RE: Dist No. 2 Gravel Pit M-1979-216 TR-1, Adequacy Review

RE: Dist No. 2 Gravel Pit, Permit No. M-1979-216; Technical Revision (TR-1), Adequacy Review

Dist No. 2 Gravel Pit M-1979-216

Figure 1: Map of the permit area showing where the imported materials are stored (circled in yellow) and the neighboring land uses.

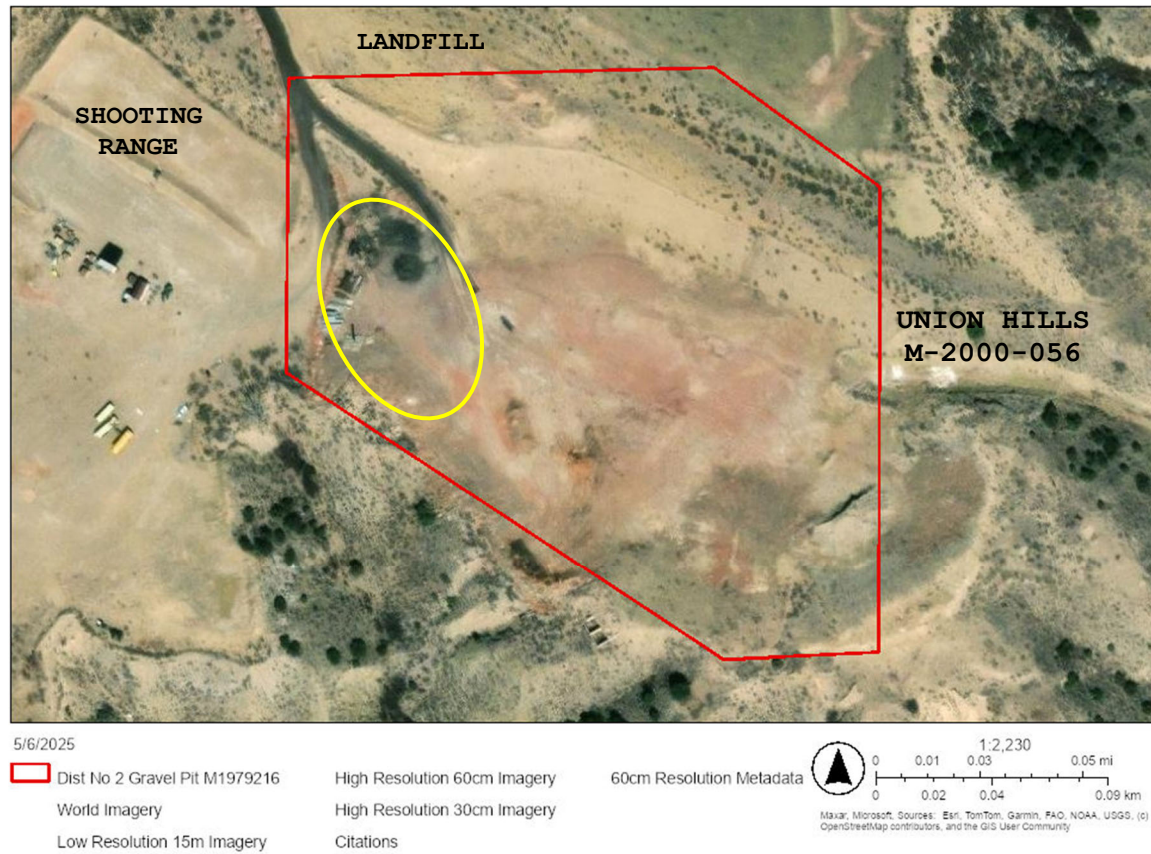
On May 7, 2025, the Division of Reclamation, Mining, and Safety (Division/DRMS) received the Technical Revision (TR-1) application to update the mining plan to include stockpiling of imported material on the permitted area of the Fremont Gravel Pit, located in Fremont County. After a review of the application, there are some matters that require further information and/or clarification prior to the Division issuing a decision for the TR-1 application. Please provide a response and any supplemental items in a cover letter addressing the following items.

1. The materials being requested to have stockpiled at the permitted site include culverts, cattle guards, guard rails, tree limbs/branches, fill material, and concrete. These materials are not acid-forming or toxic in nature, as stated in the letter from the Fremont County Department of Transportation. Will the materials be removed from the site prior to reclamation of the affected lands? If the intention is to use any imported materials as backfill during reclamation activities, please provide the following information, per Rule 3.1.5(9):

- a. A narrative that describes the approximate location of where imported material will be used as backfill, per Rule 3.1.5(9)(a).
 - b. The approximate volume of the imported material to be used as backfill, per Rule 3.1.5(9)(b).

- c. A signed affidavit certifying that the material is clean and inert in accordance with Rule 3.1.5(9)(c). Be advised, the letter provided from the Fremont County Department of Transportation is not signed and does not satisfy this requirement.

- d. An explanation of how the backfilled site will result in a post-mining configuration that is compatible with the approved post-mining land use, per Rule 3.1.5(9)(e).

- Item #1: The stockpiled materials will be removed prior to any reclamation of the affected lands. We do not anticipate reclamation operations in the near future, as we are a long ways off from beginning reclamation. We are not intending to use any of the stockpiled material to backfill during reclamation activities once that process begins.
- Item #1 c.: A signed affidavit certifying the stockpiled material is clean and inert in accordance with Rule 3.1.5 (9) (c) is included in this response. We will not be backfilling with imported material, we are only storing non-toxic material at the site.

In response to the information needed from us to accompany our technical revision application as referenced above, Fremont County will not be storing or stockpiling any material at this gravel pit that is acid-forming or toxic in nature.

Our intention is to stockpile roadway material from and for our roadways, to include culverts, cattle guards, guard rails, tree limbs/branches, fill material, and concrete. We will keep the stockpiles separate from each other and maintain in an orderly manner.
